Interactive comment on “Water-level attenuation in broad-scale assessments of exposure to coastal flooding: a sensitivity analysis” by Athanasios T. Vafeidis et al.

Response to Referee #1

Response to Referee #2

Fig. 1.

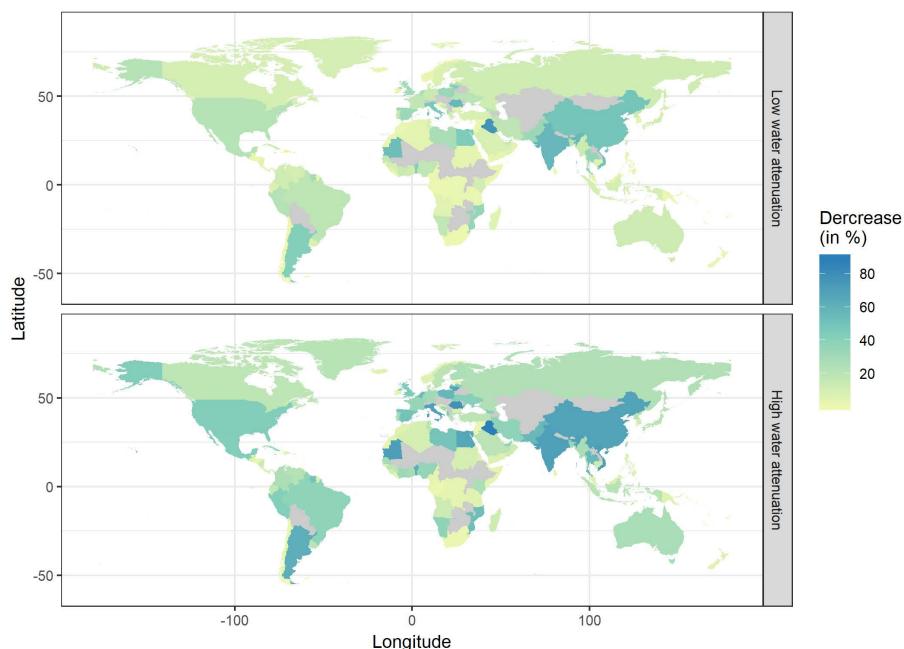
- Tab. 4 I was wondering if an additional map that shows country-by-country results (maybe only for a medium attenuation rate) would be nice to really showcase the spatial variability. The three selected countries can still be highlighted in the table.

We have followed the reviewer's suggestion and compiled a map with this information. This is now included in the manuscript as Figure 4. Further, we added some lines in the text (lines 246-249) to reflect the new figure. The map is attached and the text included now in the manuscript reads: "The reduction in impacts is not uniform across the globe and varies considerably between different countries. Some examples are given in Figure 4 and Table 4. Figure 4 shows the spatial variability of the effects of accounting for water attenuation: low water attenuation can lead to reductions in area

exposure of more than 50% and high attenuation can reduce area exposure by more than 80%.”
